平陆县 100MW 农光互补光伏发电项目

监理工程师通知单

编号: ZHJL-JLTZ-PL-061

主题: 关于东郑光伏场区巡视检查发现以下需要消缺项:

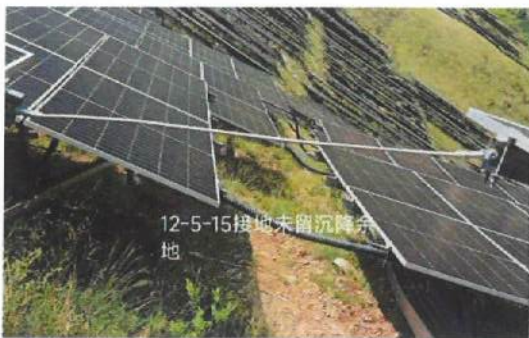
11	 12-6-6檩条连接件螺栓未拧紧	12	 12-5-28斜梁弯曲
13	 12-4-5剩余材料在组件下未处理	14	 12-4-5斜撑与斜梁间角度过小
15	 12-5-28桥架下高上低	16	 12-5-28压块倾斜

17	 12-4-14斜梁弯曲	18	 12-5-28標托螺栓未拧
19	 12-5-28胶圈未密封	20	 12-4-14拉杆未安装
21	 12-5-24拉杆未拧紧	22	 12-4-14组件呈台阶状

请贵单位按照上述问题立即消缺整改。

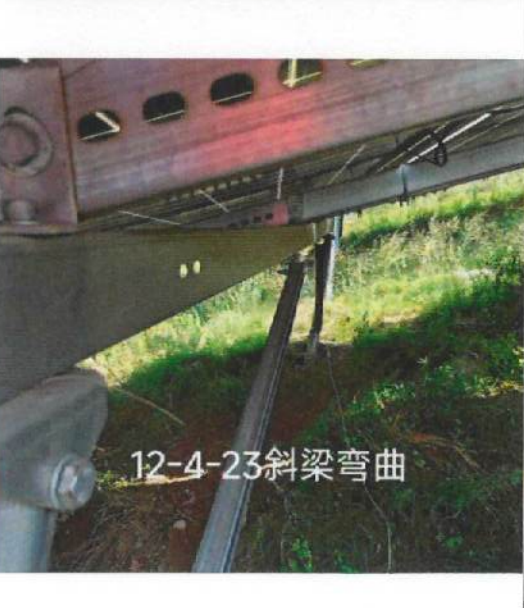
29	 12-5-24压块缺少螺母	30	 12-4-24组件呈台阶状
31	 12-5-15被拉杆螺母未拧紧	32	 12-4-24剩余压块未处理
33	 12-5-15斜梁弯曲	34	 12-5-6压块缺少弹垫

35	 12-5-15接地未留沉降余地	36	 12-5-6螺栓未按要求预留两到三丝
37	 12-5-15桥架接地断裂	38	 12-5-6背拉杆未安装
39	 12-5-15背拉杆未拧紧	40	 12-5-15压块倾斜

41	 12-5-6斜撑抱箍未拧紧	42	 15-5-15胶圈未密封
43	 12-5-16压块未垂直	44	 12-5-07桥架接地线未连接
45	 12-5-16螺栓未按要求预留两到三丝	46	 15-5-19压块缺少弹垫

47	 12-5-16背拉杆未安装	48	 12-5-7抱箍未拧紧
49	 12-5-23拉杆未安装	50	 12-5-7背拉杆未拧紧
51	 12-5-23斜撑与斜梁间角度过小	52	 12-5-7背拉杆未连接

53	 12-4-23抱箍未拧紧	54	 12-4-23桥架变形，未接地
55	 12-5-23斜梁弯曲	56	 12-4-23胶圈未密封
57	 12-5-23边上桥架连接处 上低下高	58	 12-4-23背拉杆未连接

59	 12-5-28右侧组压块未安装垫片与弹垫	60	 12-4-23背拉杆螺母未拧紧
61	 12-5-28右侧组压块未安装垫片	62	 12-6-7与12-6-22间压块螺母未拧紧
63	 12-4-23斜梁弯曲	64	 12-6-7与12-6-22间立柱安装处无灌注桩

65	 12-4-23压块螺母未拧紧	66	 12-4-23贯穿螺栓生锈
67	 12-6-7檩条连接件螺栓安装错误	68	 12-6-7斜撑与斜梁角度过小
69	 12-6-7螺栓未按要求预留两到三丝	70	 12-6-7拉杆未安装

71	 12-6-7檩托螺栓未安装	72	 12-6-22组件不齐，呈台阶状
73	 12-6-22压块未垂直	74	 12-6-22压块螺母未拧紧
75	 12-6-22檩条弯曲	76	 12-6-22拉杆未安装

77

12-6-22压块未安装弹垫平垫
